IREDELL COUNTY HEALTH DEPARTMENT

IMPROVEMENT PERMIT / AUTHORIZATION TO CONSTRUCT / OPERATION PERMIT / EXISTING SYSTEM INSPECTION

SUBDIVISION Woodleaf BLOCK / SECTION 2 LOT 66 LOT AREA .98 Ac SITE CLASS. PS DESIGN FLOW 480gpd L.T.A.R. .225 gpd/ft²

Scale: 1 inch equals 50 feet	S&ME	Woodleaf Phase 2	FIGURE
Drawn by: JBP		Lot 66	1
Reviewed by: PGP		Iredell County, NC	
Date: April, 2007	ENVIRONMENTAL SERVICES • ENGINEERING • TESTING	S&ME Project #1588-06-077

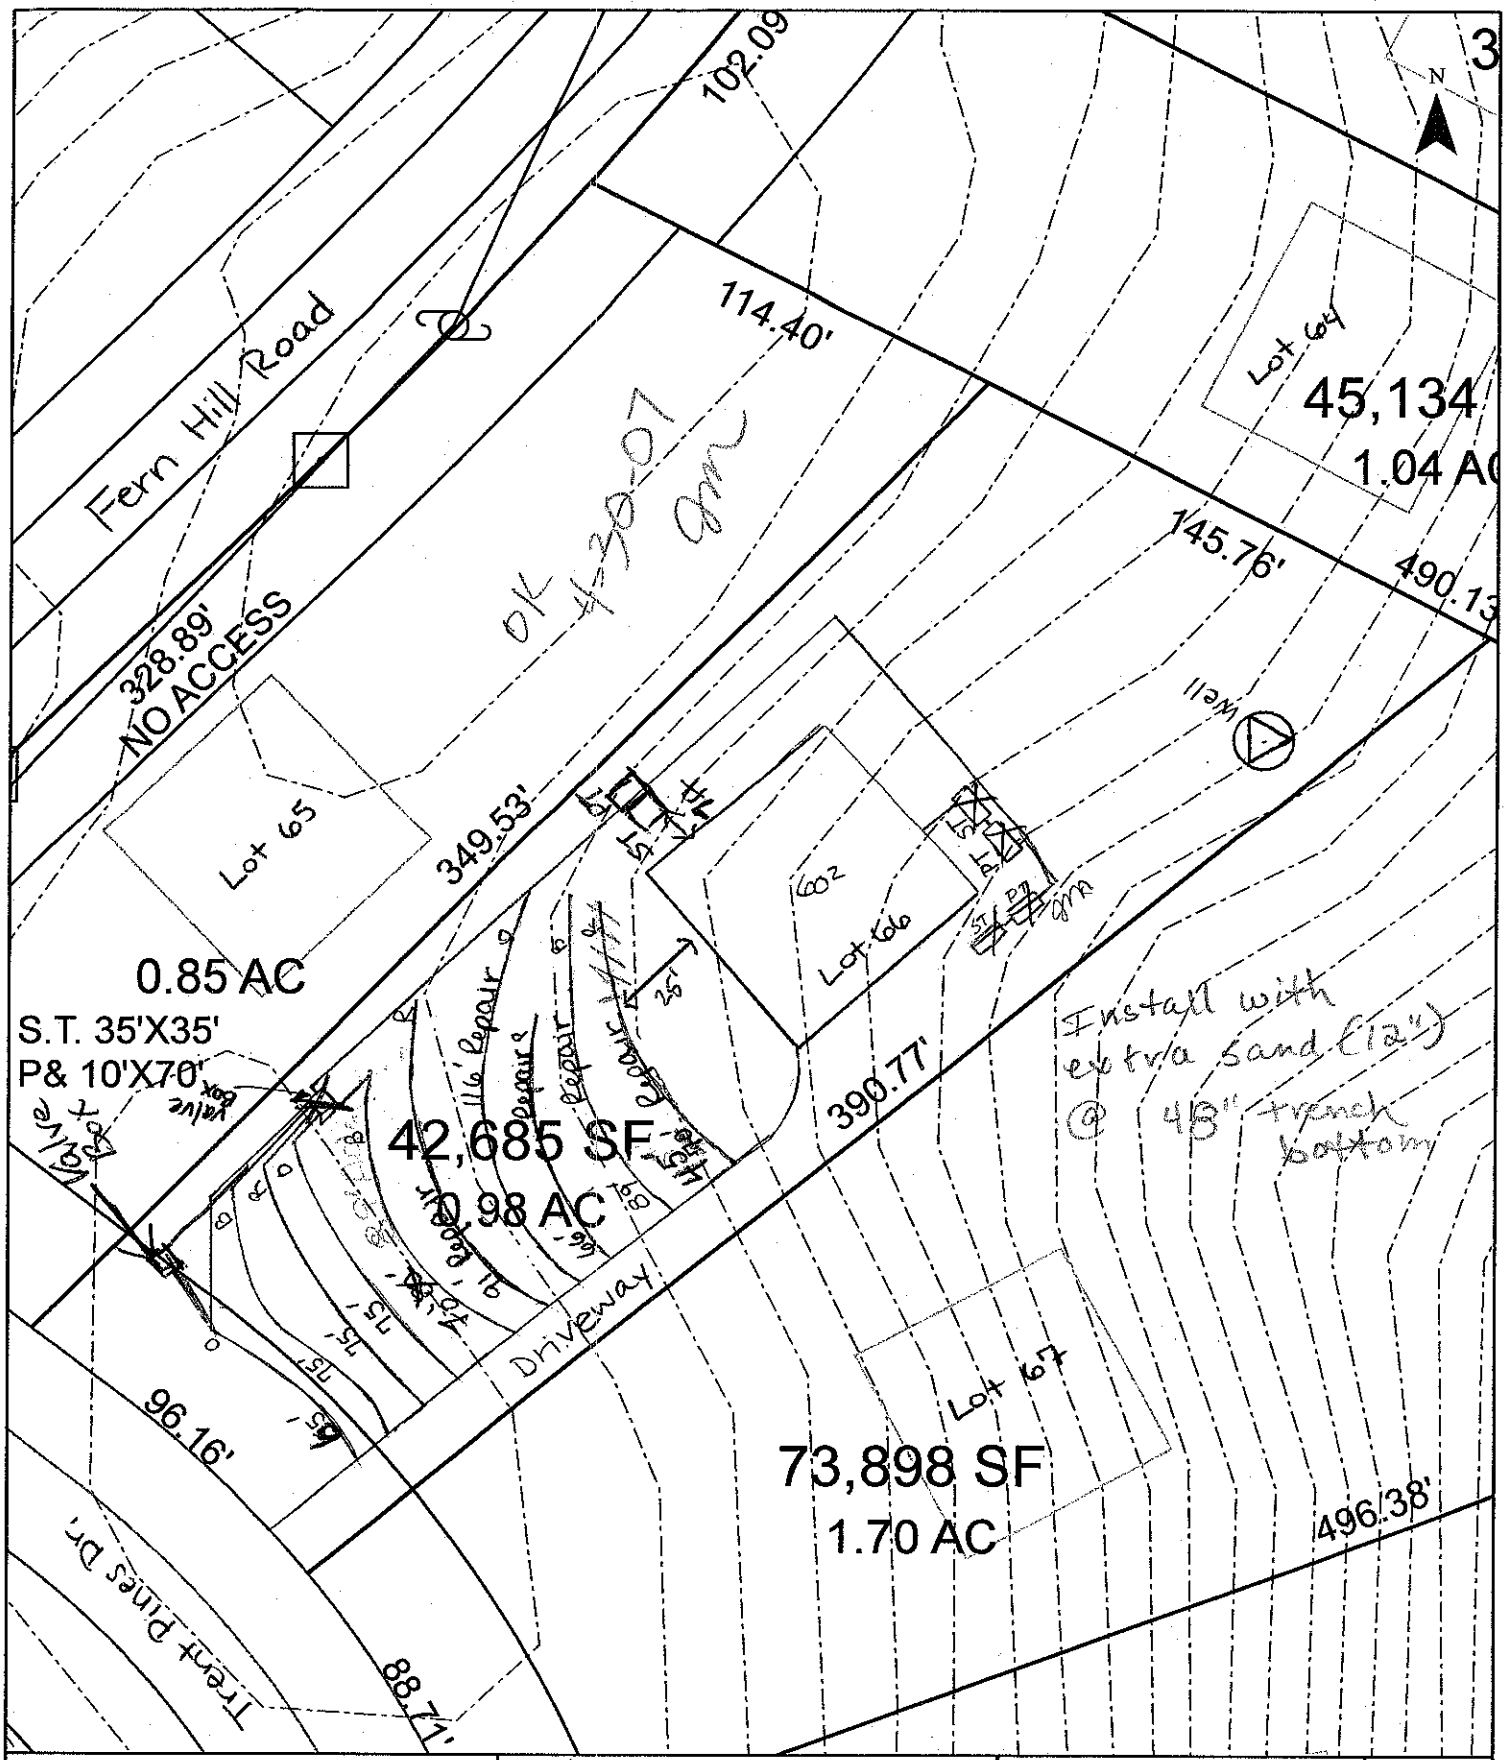
Comments/Conditions: Place tanks 50'+ from well
Install with extra sand (12") at 48" trench bottom
4/13/15 OK to run Supply line around other side (drive side) of house Must bury at least 30 inches under drive.
~~Drilled~~ 5/16" hole 3 inches in Lines
See Plan from SA ME
7/2/15 Checked tanks & 2 upper drain lines
7-6-15 CHECKED LOWER 3 LINES BA
7-7-15 CHECKED PLUMBING HOOKUPS BA
8/28/15 Set 2' Head Pressure
Electrical OK
Alarm OK
Maint. Contract OK

Comments/Conditions: House CHANGED TO CRAWL SPACE.
MAINTAIN AT LEAST 5' SEPERATION FROM SEPTIC REPAIR WITH HOUSE.
HOUSE WILL NOT EFFECT SEPTIC & WELL. SL

OK TO MOVE TANKS TO LEFT SIDE.
MOVED PLUMBING WHEN CHANGED FROM BASEMENT TO CRAWL. SL 6/12/15
